118 W. MERCER

SDCI #3036517-LU

DESIGN REVIEW BOARD RECOMMENDATIONS #2

05/04/2022

BUILDING ELEVATION - DRB REC MEETING #1(2021.08.04)

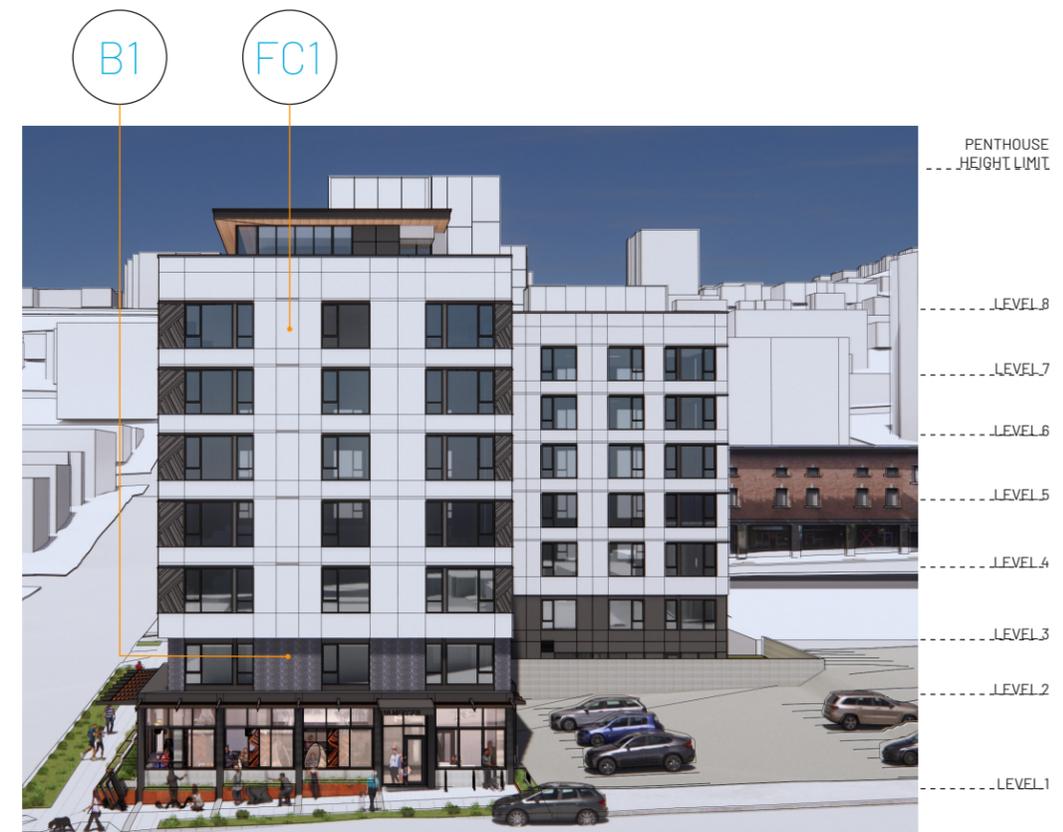
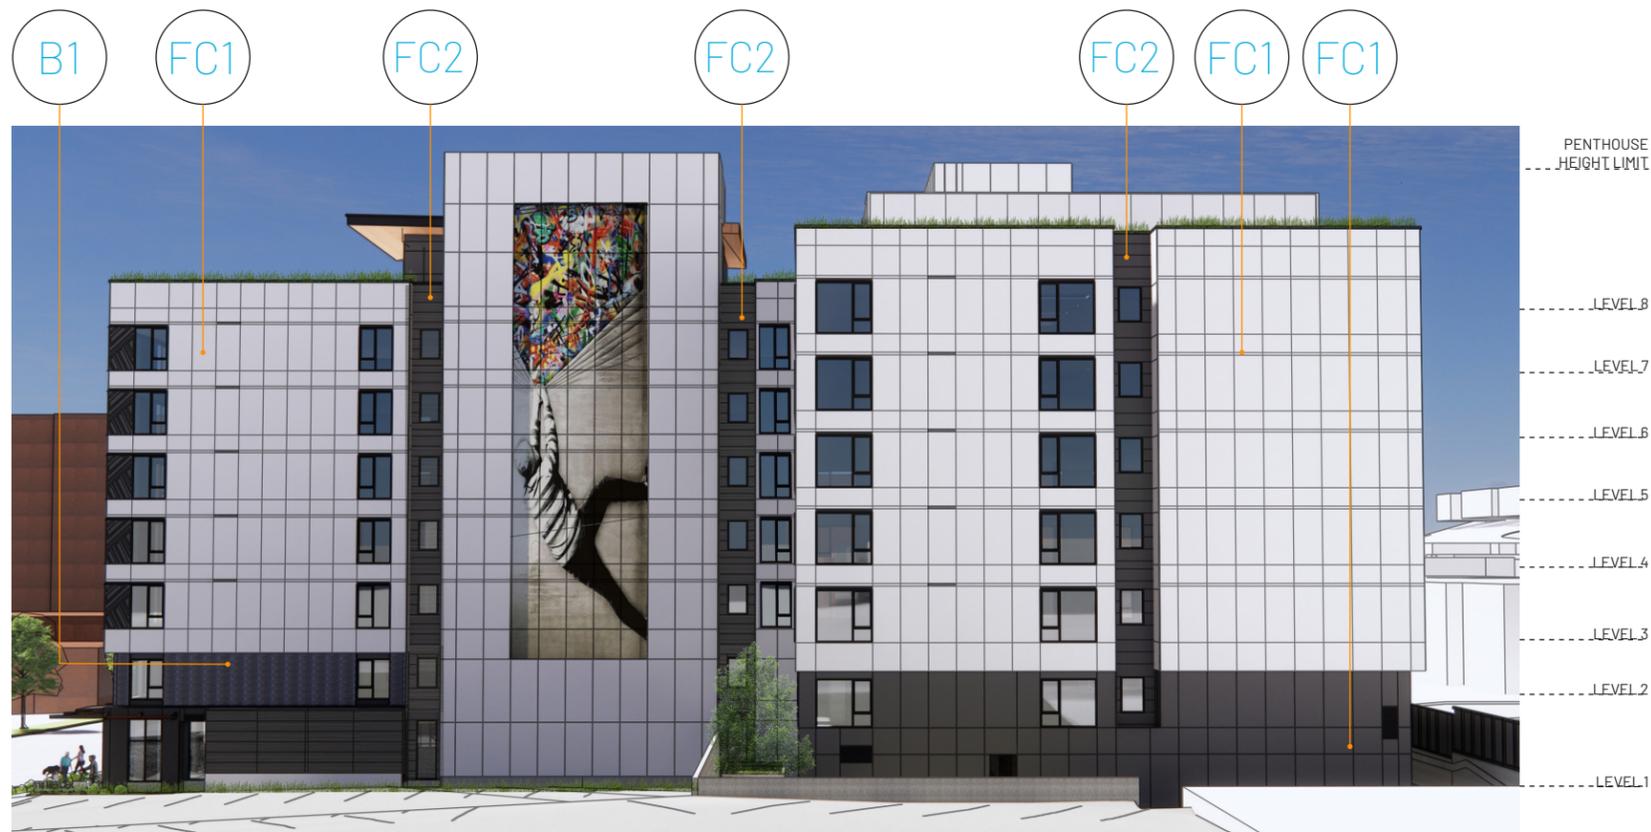
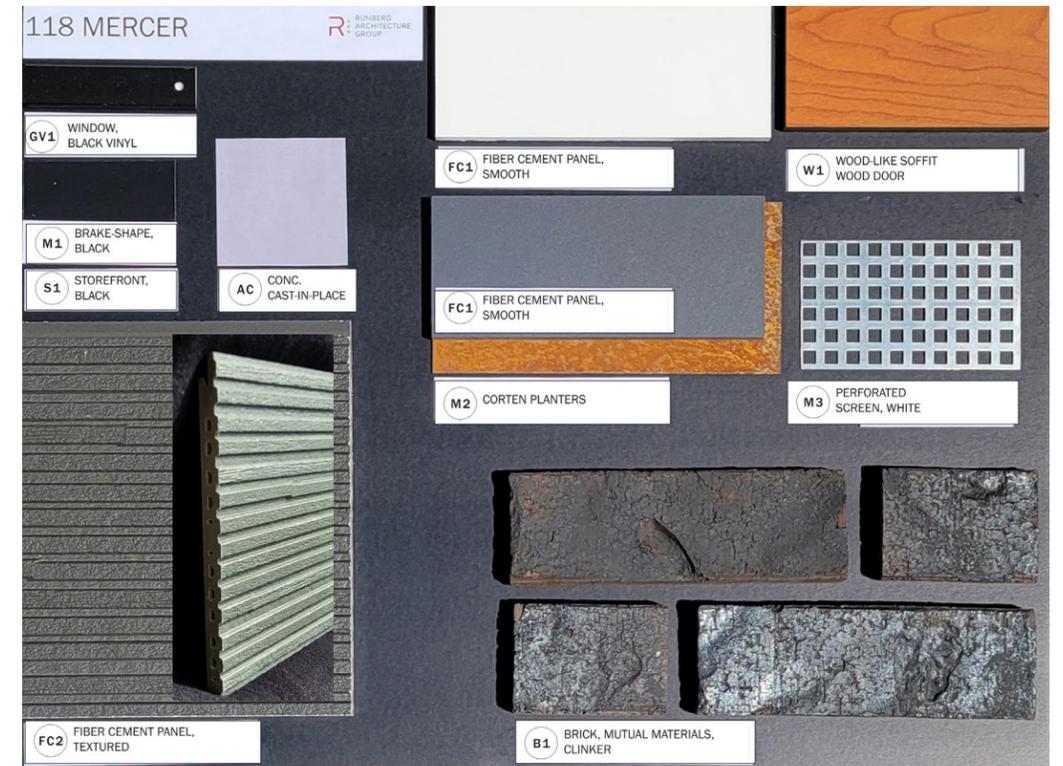
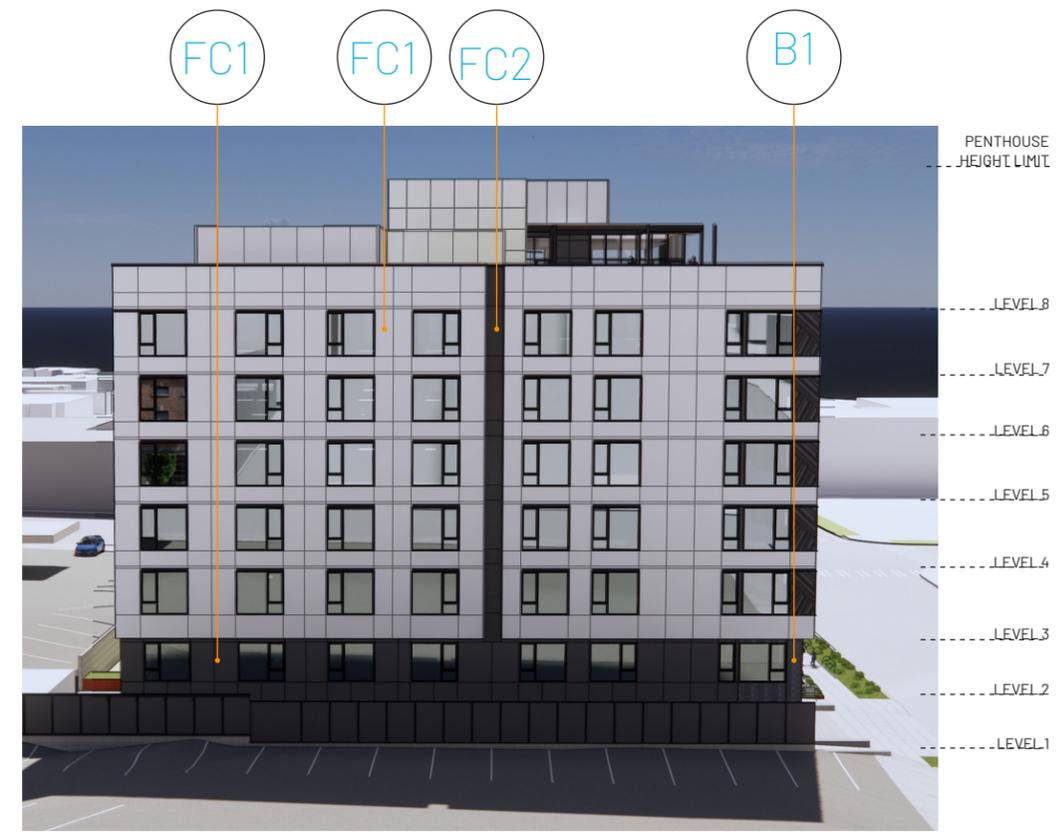
- Brick Cladding: LURC members were unanimous in their comments and did not support extending any of the brick beyond what was shown in the DRB presentation. LURC members reviewed several design options presented by the design team and ultimately felt extending the brick on the north side did not add any design value and more importantly any value to pedestrians and community members. LURC encouraged the design team to terminate the brick at the northwest corner of the building.
- Same comment on extending cladding to the east and south side walls. South side faces parking lot and is mostly covered by retaining wall and landscaping. Future development will cover this façade.
- Phenolic Panels on façade: LURC members were unanimous in their support for the phenolic panels, especially on the east facing facade near lobby.

BUILDING ELEVATIONS - NON-STREET FACING FACADE - OPTION 1

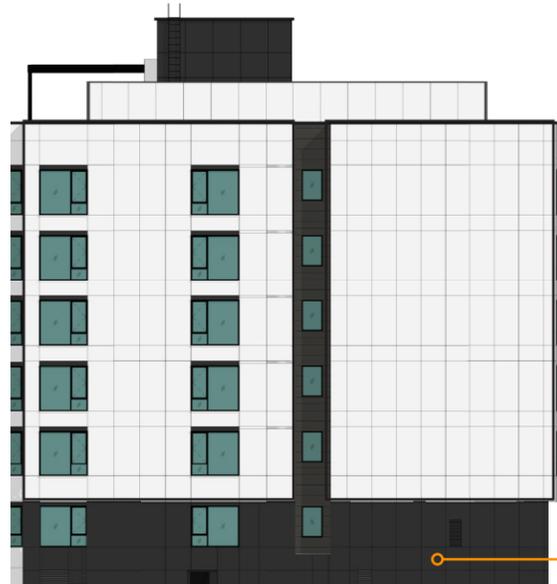
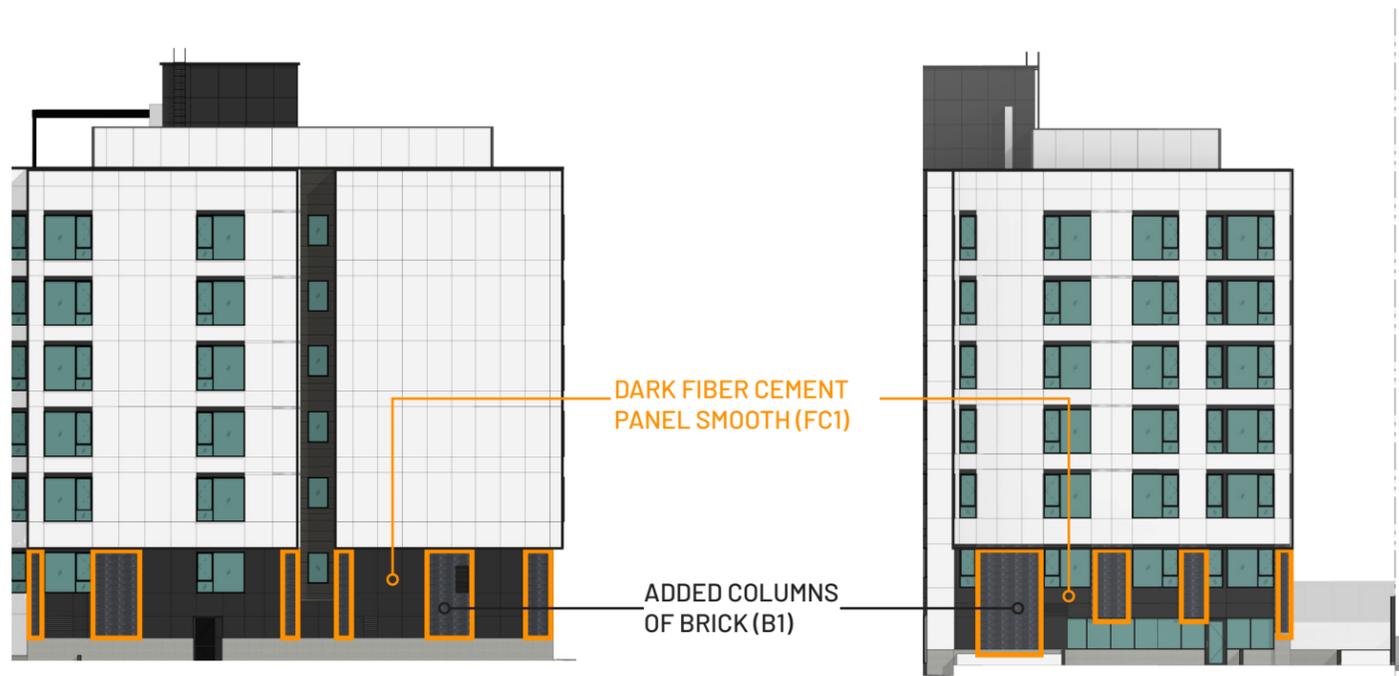
1. Replace the dark-colored fiber cement panel material proposed on the first two-levels of the non-street-facing facades with the brick material proposed for the two-story base of the street-facing façades (DC2-B-1. Façade Composition, DC4-A-1. Exterior Finish Materials, Uptown DC4-1-b. Quality Materials).

ADDED COLUMNS OF BRICK (B1)
